Water and Wastewater Study Combined

PRELIMINARY Basis of Design Report	CITY OF					
		SCOTTSDALE					
	ACCEPTED AS NOTED						
	REVISE AND RESUBMIT	9379 E San Salvador Dr. Scottsdale, AZ 85258					
	Disclaimer: If accepted; the preliminary approval the condition that a final basis of design report w submitted for city review and approval (typically PP case). The final report shall incorporate furthe design and analysis requirements as defined in t standards and policy manual and address those the preliminary review comments (both separate herein). The final report shall be submitted and a the plan review submission. For questions or clarifications contact the Water Planning and Engineering Department at 480-31	ill also be during the DR or er water or sewer he city design items noted in and included approved prior to Resources					
	BY Idillon DATE	5/11/2020	2	Anna	Ninc	orino	<u>.</u>
	Address comments below and herein BOD. Conform to stipulations listed.	on a final	planr

SOUTHDALE

FINAL WASTEWATER BASIS OF DESIGN REPORT

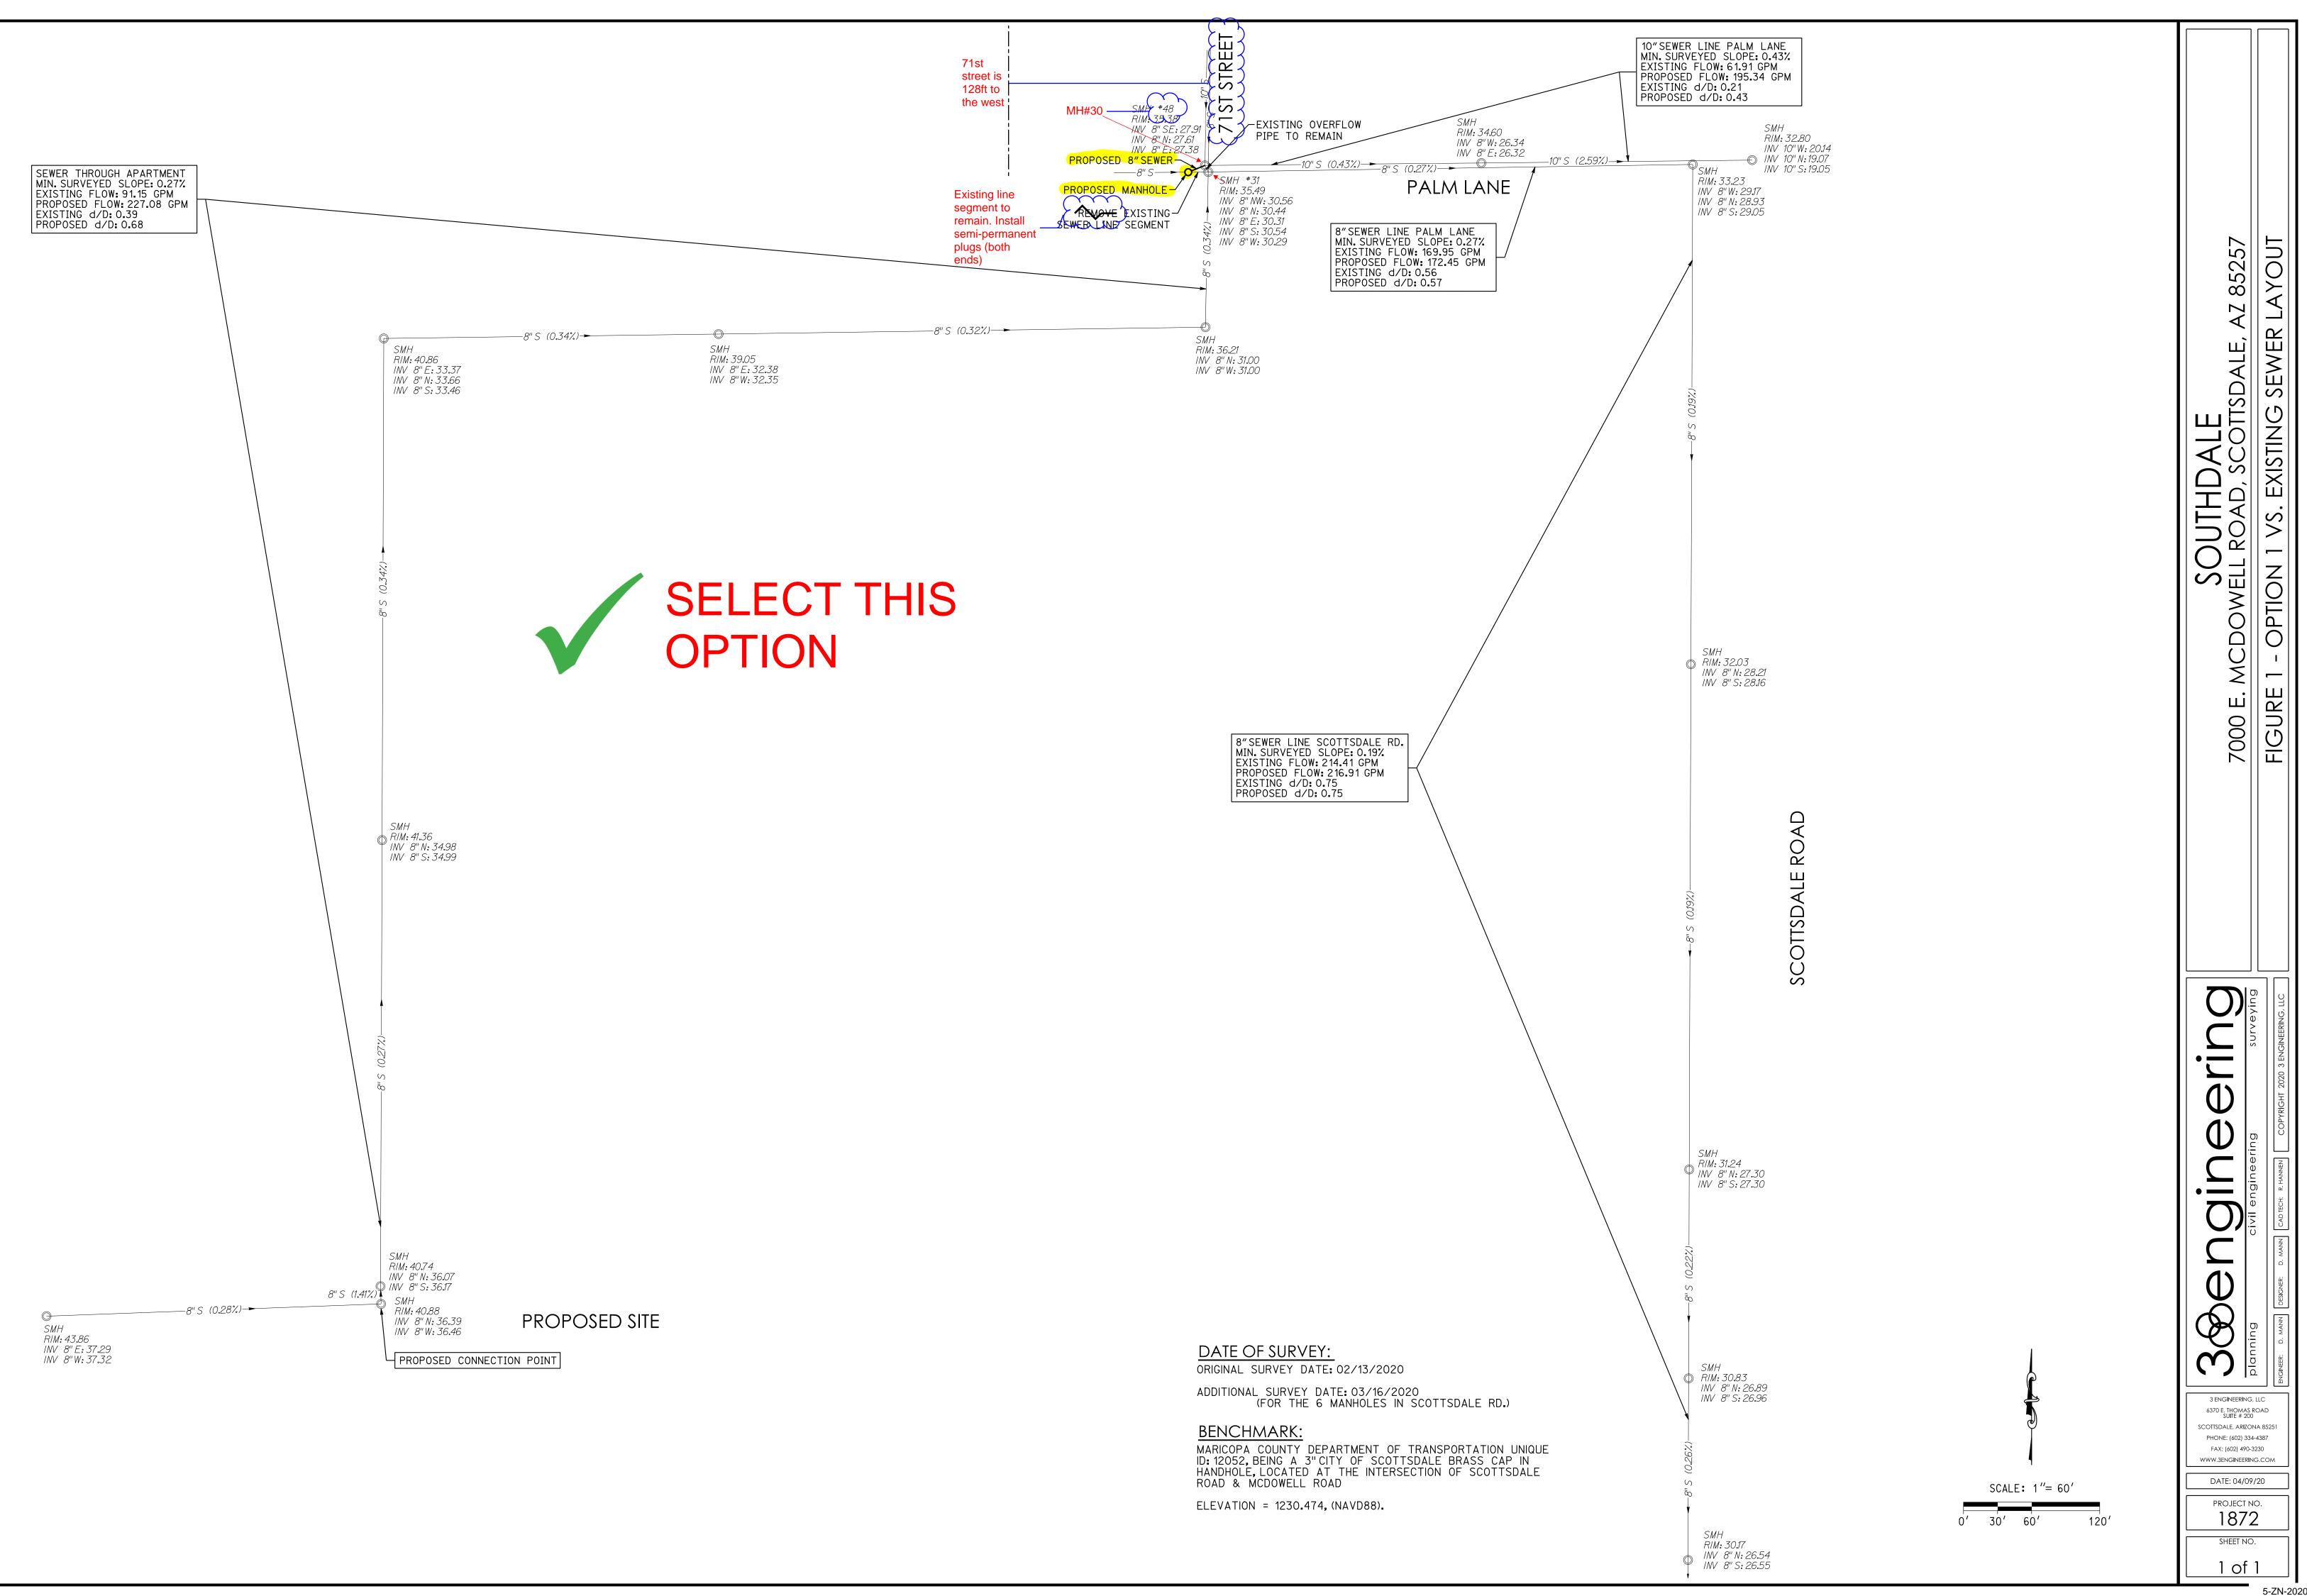
Stipulation: All onsite sewer and p backwash to be routed to sewer runni and parallel to and east of N. 70th Str waste flows to McDowell Rd sewer) 	ing north			ator Dag	is of Dosign	
un	2) Stipulation: Offsite construction remanhole and line segment to be added Lane approx. 124ft east of 71st Street See figure to right and on Option 1 util herein. Line segment shall be angled degree angle to join manholes. Line s approximate length will be 8ft. Reword manhole base to accept re-routed flow	equired. New ed on Palm t centerline. ility plan at a 45 segment k receiving	Rep 3 er	Dort Dort gineering Job 19, 2020		is of Design	
ک	 3) Stipulation: Pool backwash flows equalized and limited to 50gpm peak public sewer proposed. Use of a cartr not an acceptable solution to reducing backwash flows. Refer to the page for the	shall be into the 8" idge filter is g/eliminating blowing this	71st street is 128ft to the west	MH#30 SMF *48 RIM 33357 HW 8"SE: 27.9 IW 8"SE: 27.9 IW 8"F: 82.75 IW 8"F: 82.75	FIFE TO R	EMAIN R

cover page for guidance on informatic be provided in the subsequent design and/or plans on how to properly equa flow.	report	Existing line segment to remain. Install	PROPOSED B" SEWER B" S	SMH •31 RIM: 35.49 INV 8" NW: 30.56 INV 8" N: 30.44	<u>s (0.43%)</u> 8" s (0.27%) PALM

4) All new connections to the public so be min 6-inch and be per MAG 440-3. utility plan.		semi-permanen plugs (both ends)		(1) W 8 E: 30.51 IW 8"S: 30.54 IW 8"W: 30.29 S 8"W: 30.29 S 8"W	8"SEWER LINE PALM LA MIN. SURVEYED SLOPE: 0 EXISTING FLOW: 169.95 0 PROPOSED FLOW: 172.45 EXISTING d/D: 0.56 PROPOSED d/D: 0.57	
			-8" \$ (0.32%)— -	R	БМН

Select this option w/ pool backwash equalization
